**SUBJECT: The Sod Guy
Sales Lot
Drainage Letter – Lot 1 in Appaloosa Highway 24 Subdivision Filing No 1A**

PCD FILE NO. PPR1925

SHEET NO:
C-01
 DATE:
 09/10/19
 PAGE NO:
 1 OF 2

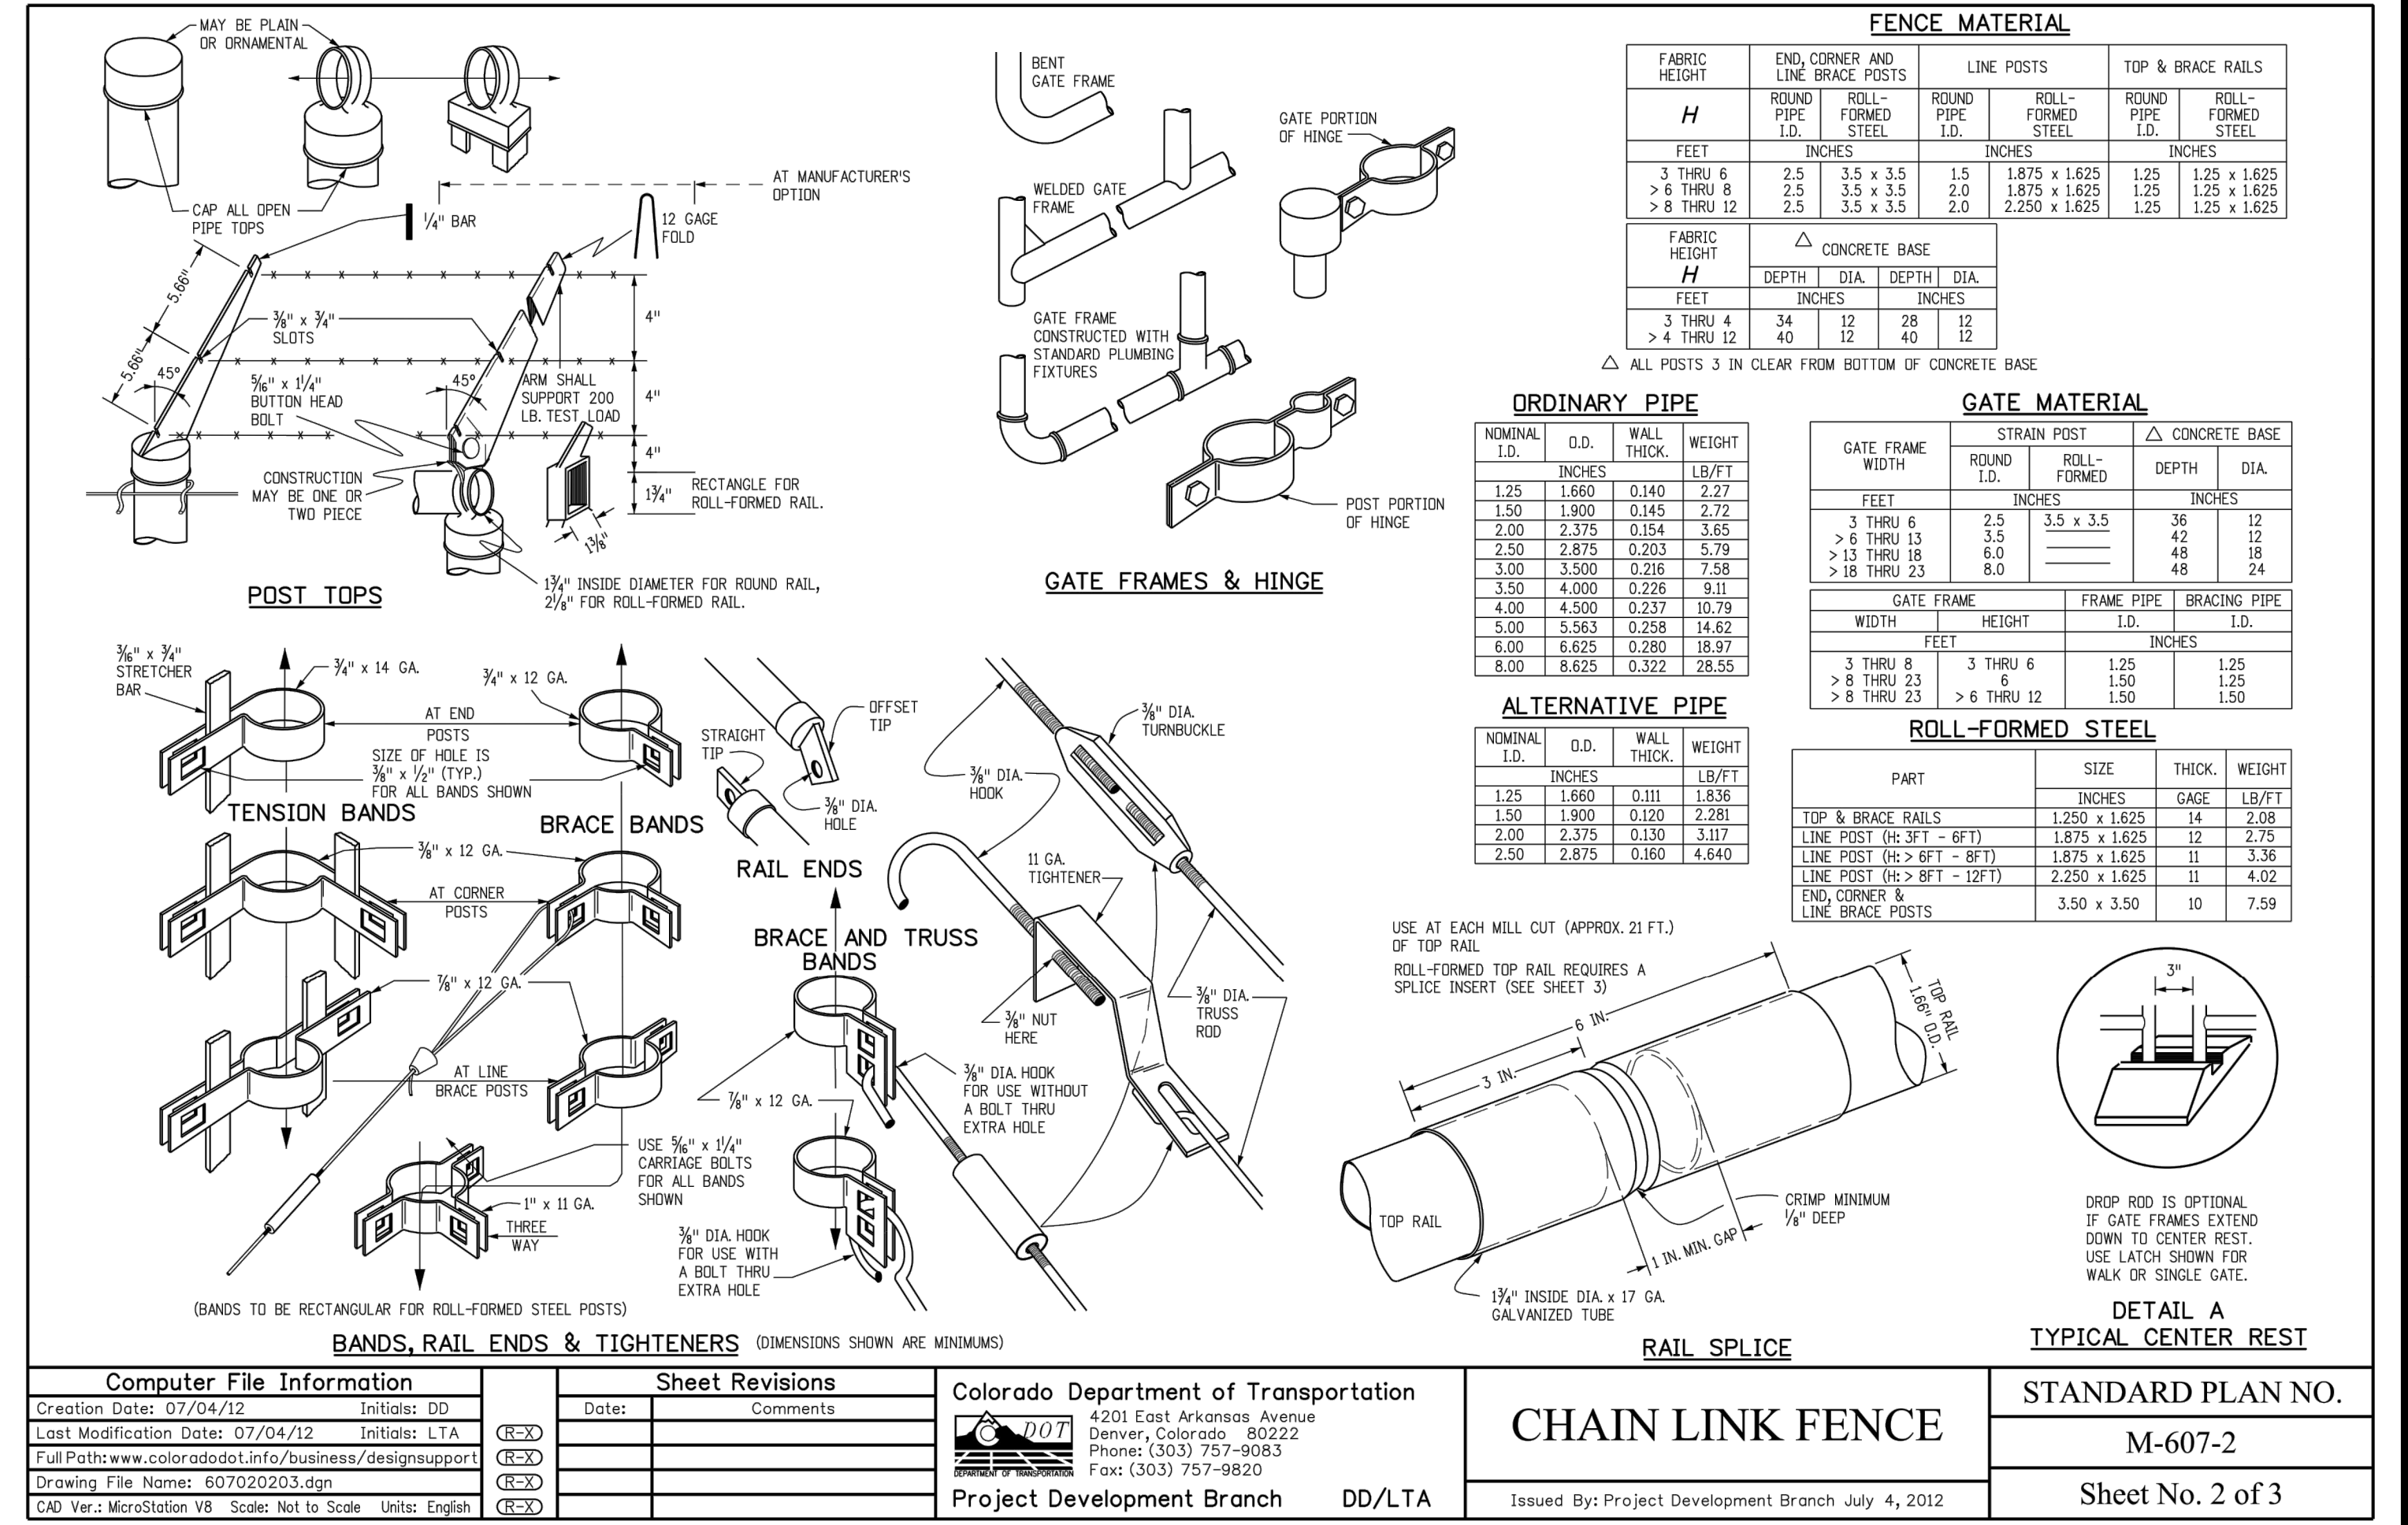
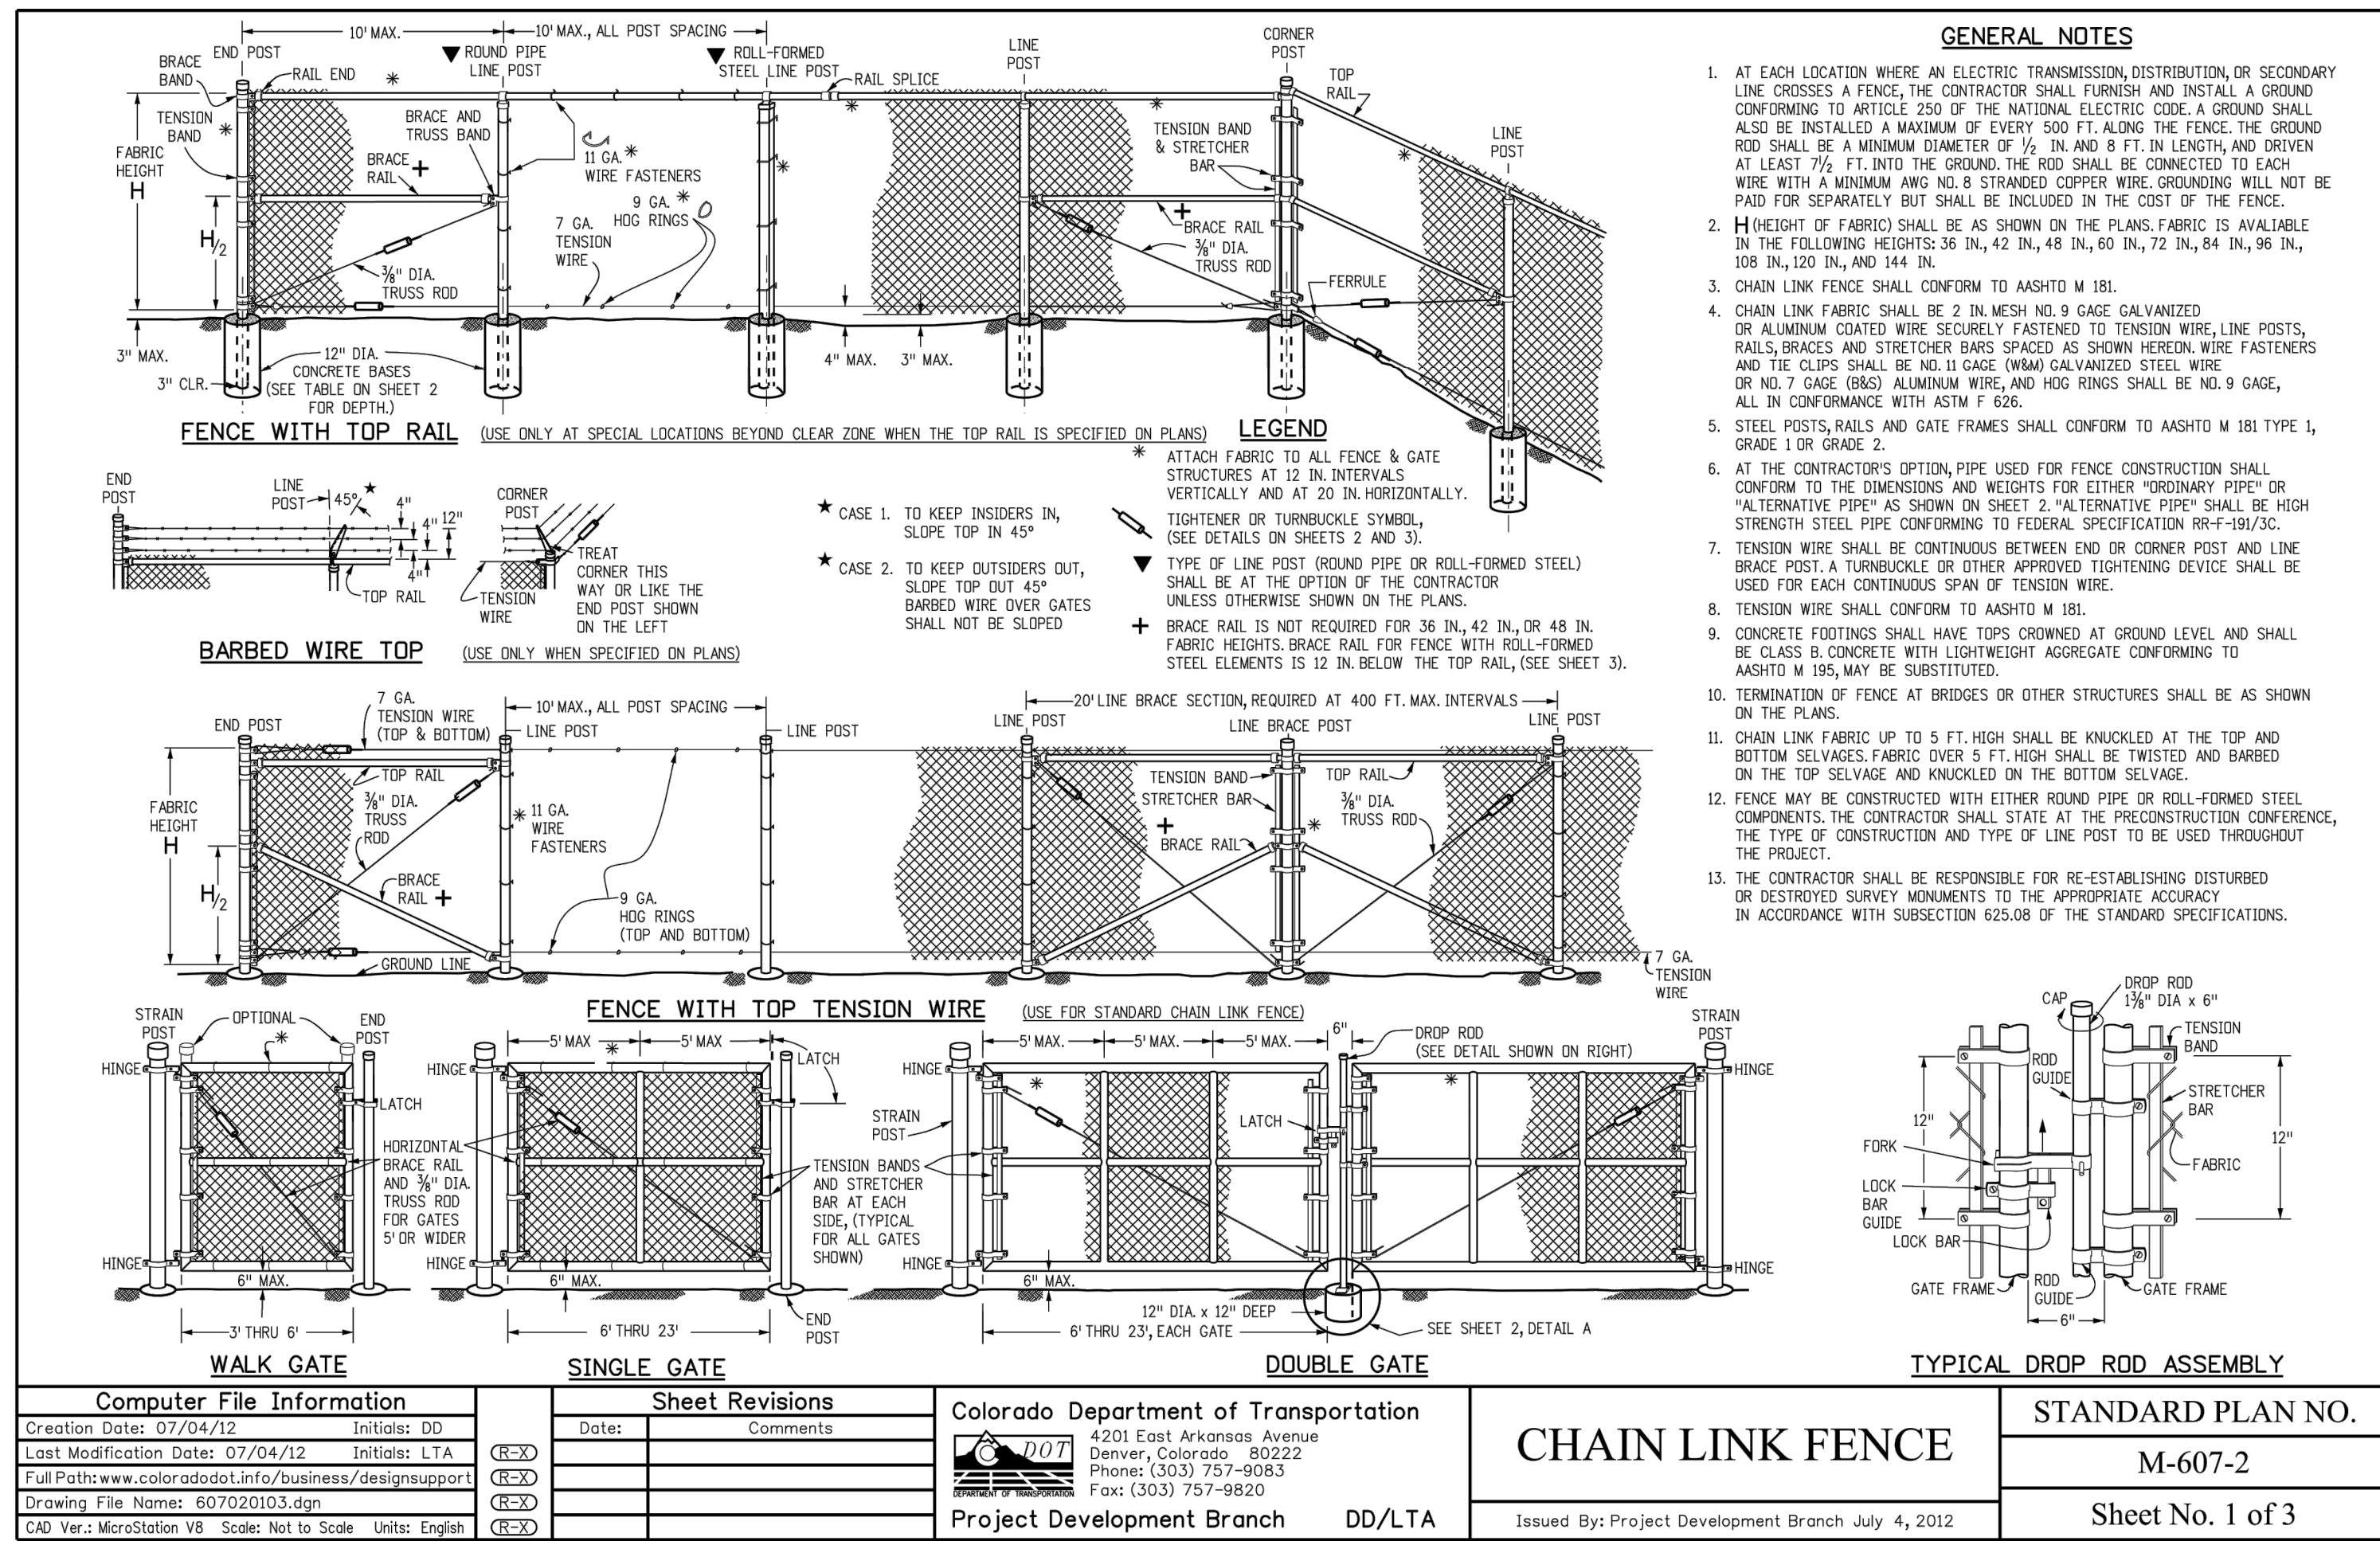
Remove this sheet from the drainage letter
